**Historical Architectural Review Board**  
**COA Preliminary Review Sheet**

**HDC-2025-00091**

**Address:** 231 N Fulton Street

**Proposal:** Legalize the installation of a Multi-Zone Mini split system slim duct and units along Emmett Street.

**Current condition (Applicant)**

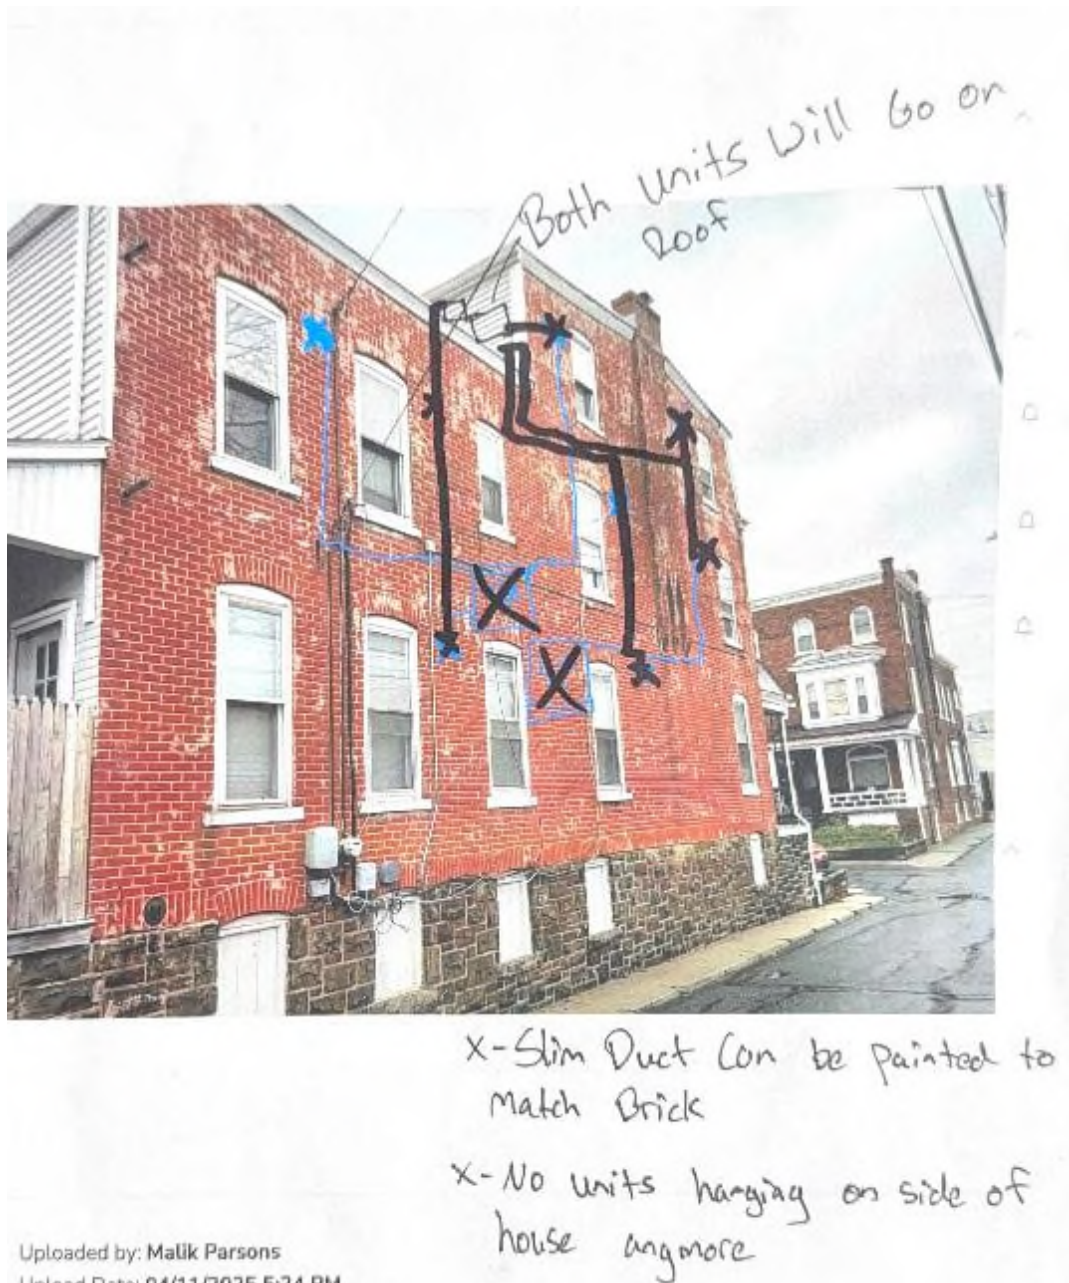
**Observations & Comments:** This application follows the denial of the legalization of the mini-split installation at the October 6, 2025, HARB meeting. The current HVAC system is installed on the exterior wall of a corner building, along Emmett Street. Two units are mounted on the wall near the top of first floor windows and various equipment lines are routed across the wall surface.

The current Slimduct lines are white and highly visible on the exterior. The applicant's proposal to paint the Slimduct to match the exterior brick is appropriate to make these elements more inconspicuous and blend in. The proposed work includes brick repair. More information would be helpful to understand the intent, location, and materials used in brick repair.

- The roof-mounted mechanical units are set back from the roof edge so that they are not visible from a public right-of-way.
- Brick repair is performed so that any units and mortar match the existing in dimension, materiality, texture, pattern, and color.

- The roof-mounted mechanical units are set back from the roof edge so that they are not visible from a public right-of-way; minimum 5'

- Brick repair is performed so that any units and mortar match the existing in dimension, materiality, texture, pattern, and color. This would be sent to staff for approval.
- As demonstrated in submitted photos and in discussion, all Slimduct lines would be routed vertically to avoid major horizontal runs.
